THE BRAKE PAD PARTNERSHIP
Compilation of Technical Reviewers' and Stakeholders' Comments on
Watershed Modeling Draft Report
July 22, 2007

COMMENTS RECEIVED

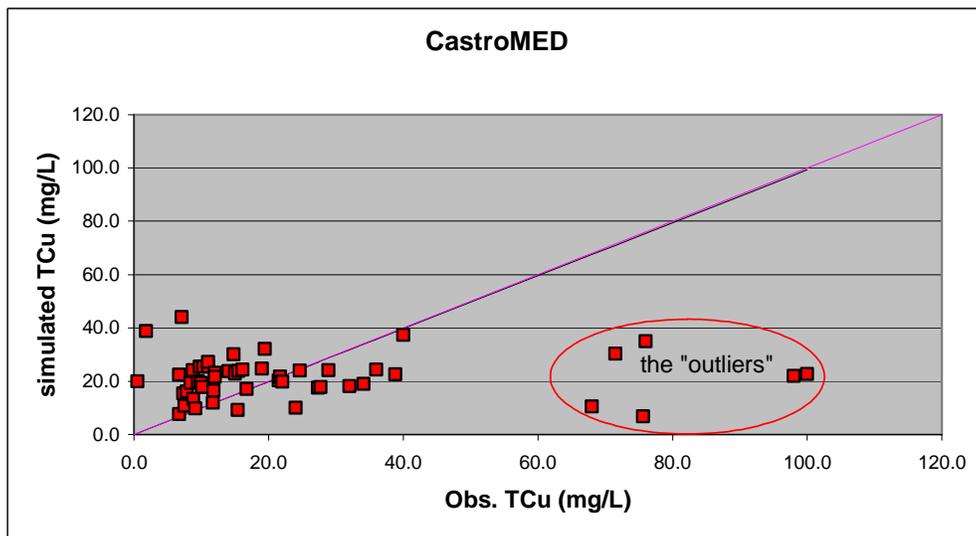
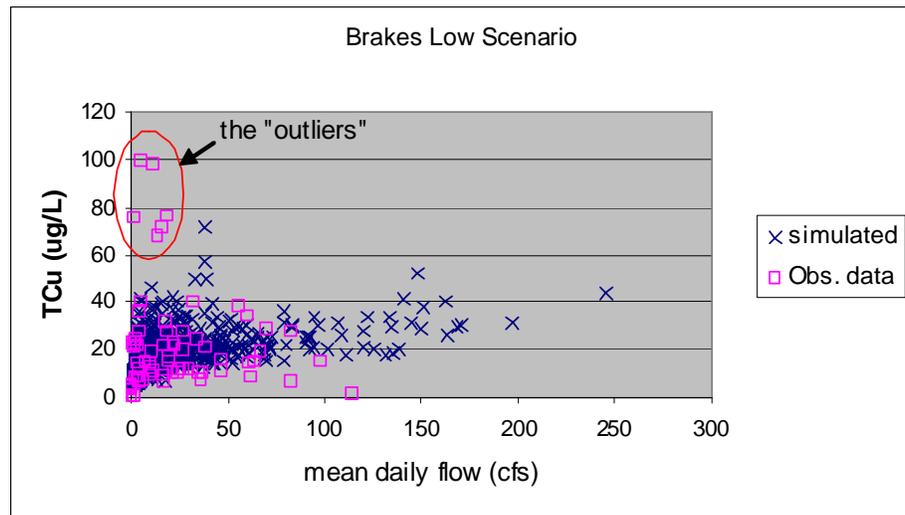
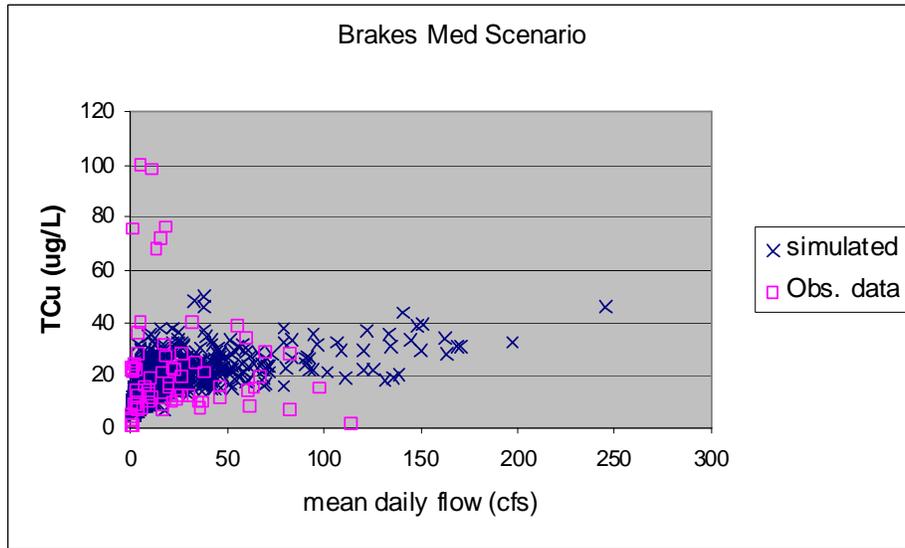
P31, Third paragraph, Last sentence: What reason do we give to consider these 6 points as outliers? An alternate hypothesis is that the model is missing a significant loading, because the observations are 4 to 5 times higher than the predicted values. I do suggest more text on this topic.

15. Is there a reason for dropping the six high observed Cu concentrations in Figure 3.4? Agreement between simulated and observed concentrations is not so good when they are retained.

Demonstrate the decision to throw out 6 of the data points is statistically valid; there are specific test to demonstrate this. Why 6, why not 5 or 7? If the data cannot be thrown out statistically they should be included.

Jim Carleton has done additional plots (attached) demonstrating that those 6 points correspond to lowflow conditions and can reasonably be considered outliers.

See response to Jim Pendergast's question on this, and the attached plots of outliers by Jim Carleton.

See responses to Jim Pendergast's questions, and attached plots.

MEAN ANNUAL COPPER FLUXES IN THE WATERSHED MODEL (1000 kg/yr)

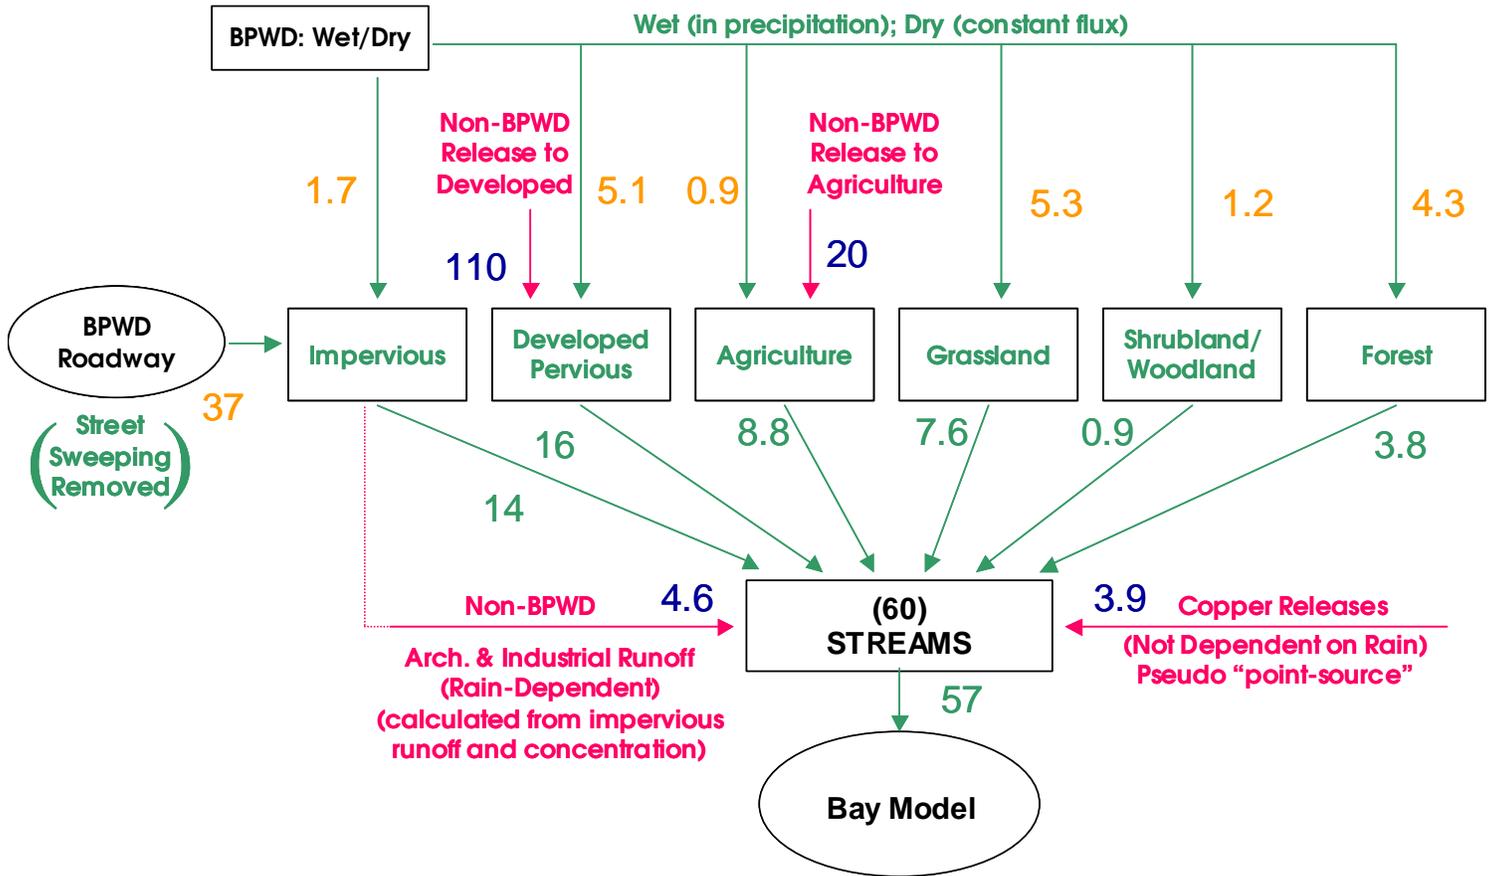
Figure 2.6 could use more work; I cannot put my hand on it, but it is not particularly useful in the present form.

That’s disappointing as it was well-received, after some further refinements, at the BPP Stakeholder Meeting. A copy of the figure with flux numbers is attached.
